MEMO TO: Prospective Bidders
FROM: Kimberly Toon, Purchasing Manager
SUBJECT: **Addendum #1:** ITB – Mazarick Park Tennis Center Tennis Sitework
DUE DATE AND TIME: **October 31, 2024; 2:00 p.m.**

1. The Bid Documents are hereby modified per the attached Addendum #1 dated October 28, 2024. To include the following:

**Mazarick Park
 Tennis Center**
 730 Filter Plant Road
 Fayetteville, North Carolina

4 Receptacle Wiring Detail SCALE: Not To Scale

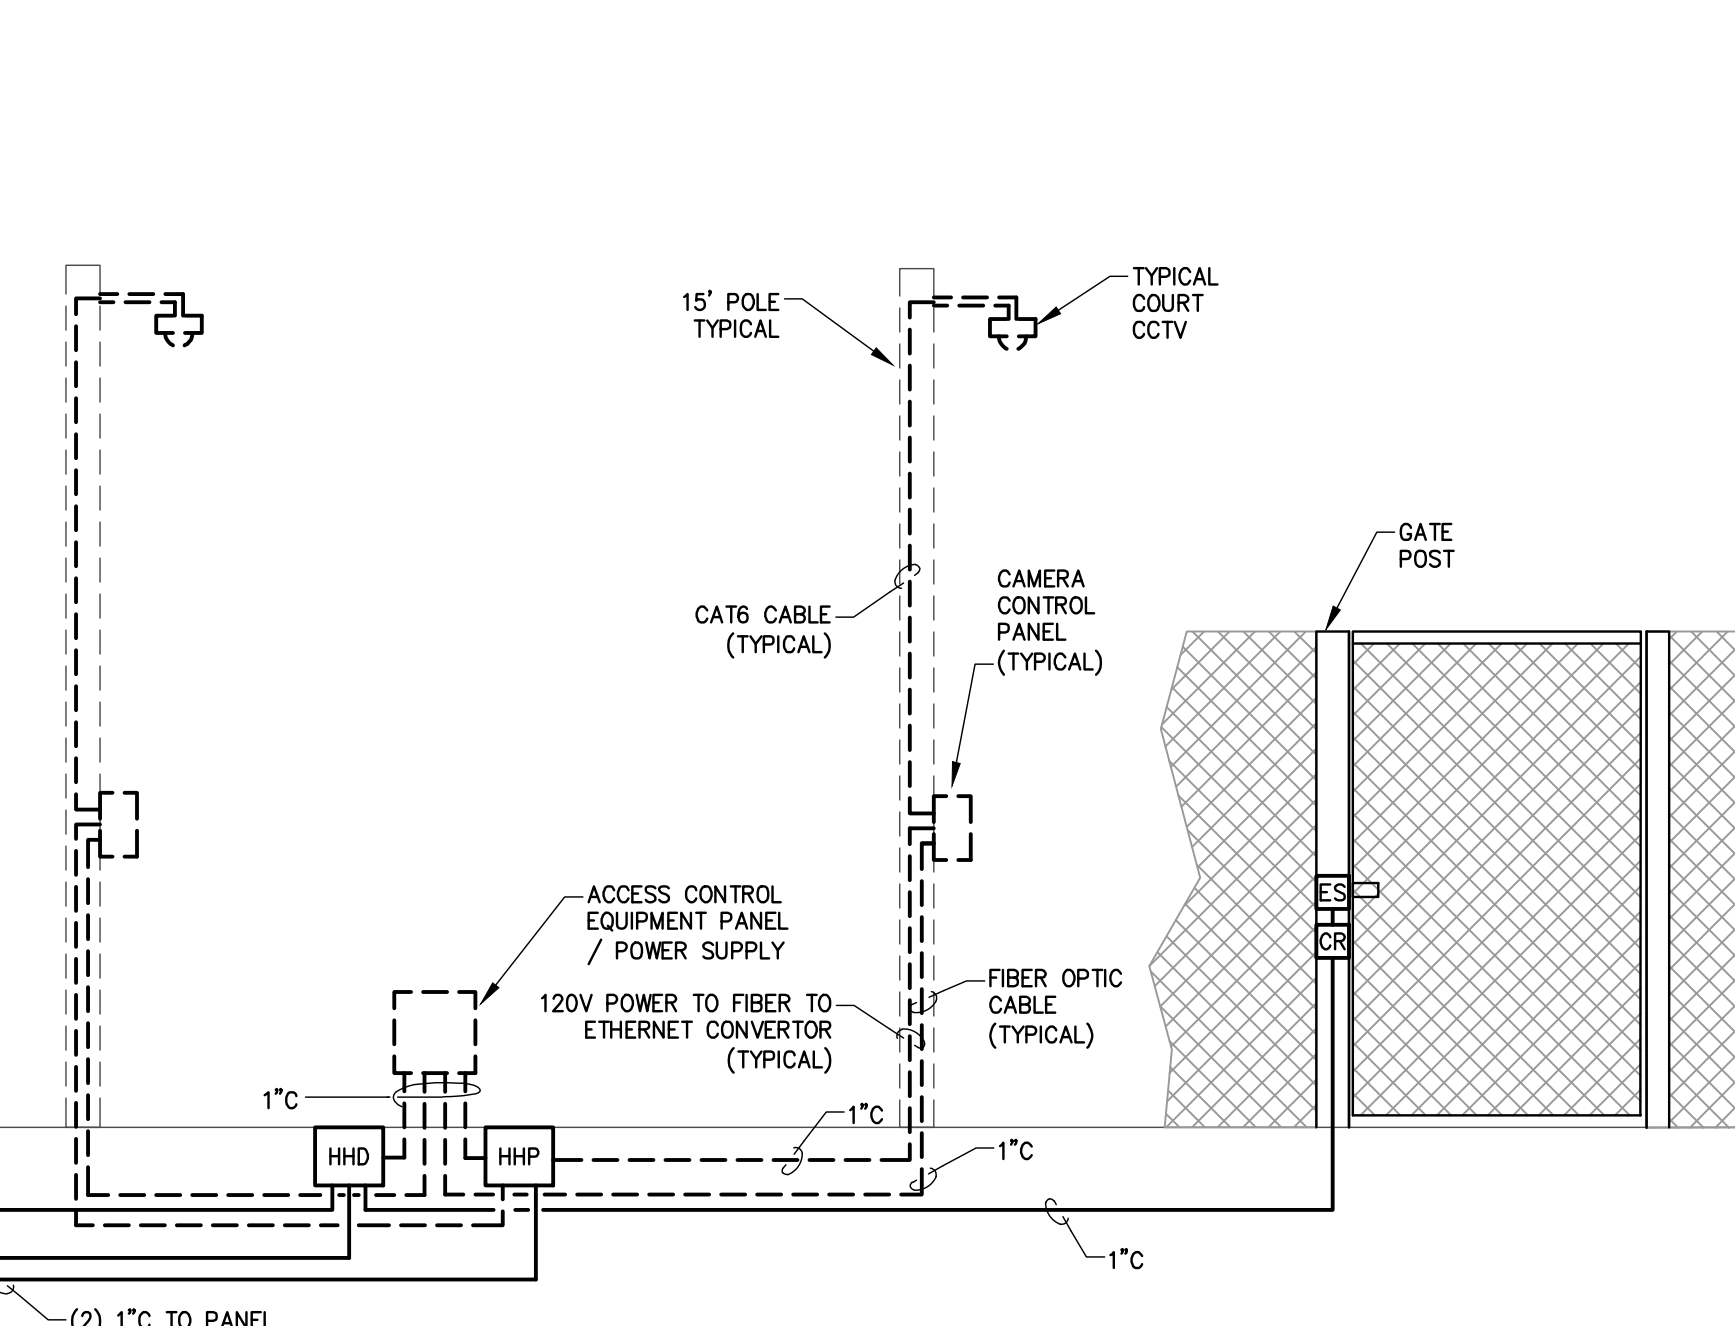
Question: Could you provide drawings: E1, E2, E3?

Answer: The electrical sheets E1.0, E2.0 and E3.0 are attached to addendum 1.
